**PLANNING COMMISSION AGENDA ITEM NO. E.1**  
**08/15/2023**

**SUBJECT:** Planning Commission Staff Report.docx

An application for a tentative parcel map to subdivide a 5.29-acre parcel (MS 354-22) and a design review (DR 22-011) for a new sit-down restaurant known as Lazy Dog, with related site improvements, located on the south side of Sand Creek Road and the east side of State Route 4 (APN 019-110-074 and a portion of CCWD owned parcel APN 019-110-023).

*Proposed Building Elevations*

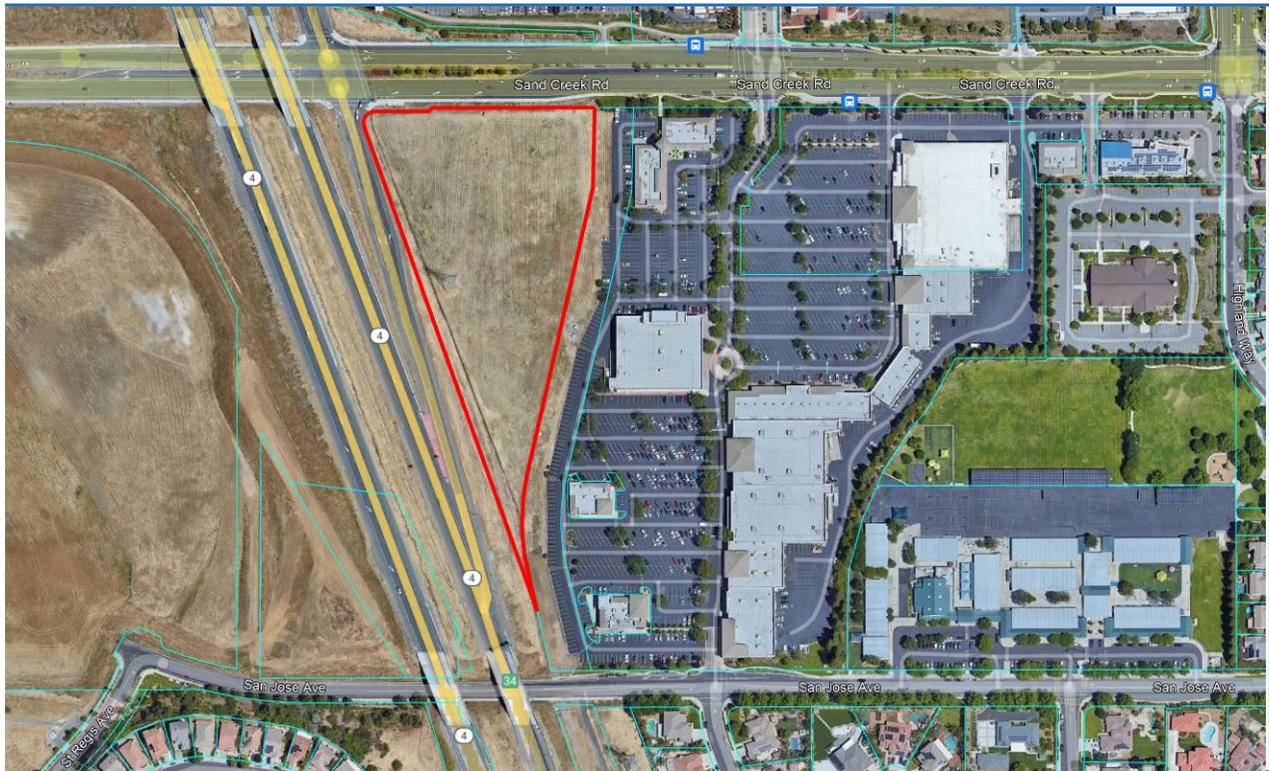
The application was submitted in October 2022 and, since then, the design has gone through multiple iterations. The current architectural proposal is in response to the City's peer review architect, Larry Cannon's, comments on the third design submittal. A copy of the resulting drawings and e-mail comments are attached for reference and include suggestions to augment the building design by:

- 1) adding a tower element that is typical of all Lazy Dog restaurants, but was removed during the second iteration of the project,
- 2) changing the materials of a projecting stucco wall to stone to provide depth,
- 3) providing depth to all stone pilasters, and
- 4) adding additional architectural elements to the east elevation to break up the large wall plane.

In the final proposed design (see below), the applicant re-incorporated the tower element, but at a slightly reduced height than is typical for Lazy Dog Restaurants (31 feet instead of 38 feet). There was no additional depth added to the stone pilasters, which currently project 10 ½ inches; therefore, staff recommends that the projection be increased to 18-inches in order to break up the building's box-like appearance and comply with the City's commercial/industrial design guidelines. Staff has included a draft condition of approval #11, which requires the applicant to add more depth to the pilasters by increasing the projection from 10 ½ inches to at least 18 inches.

In response to the peer review comments, the material to the projecting southeast corner wall was changed from stucco to stone veneer, and stone pilasters were added to the east elevation to break up the monotonous wall. Staff has included draft condition of approval #10, which requires the applicant to add landscaping to the west wall of the trash enclosure in order to be more comparable to the landscaping area on the east wall of the trash enclosure and to minimize the prominence of service areas as required by the commercial/industrial design guidelines.
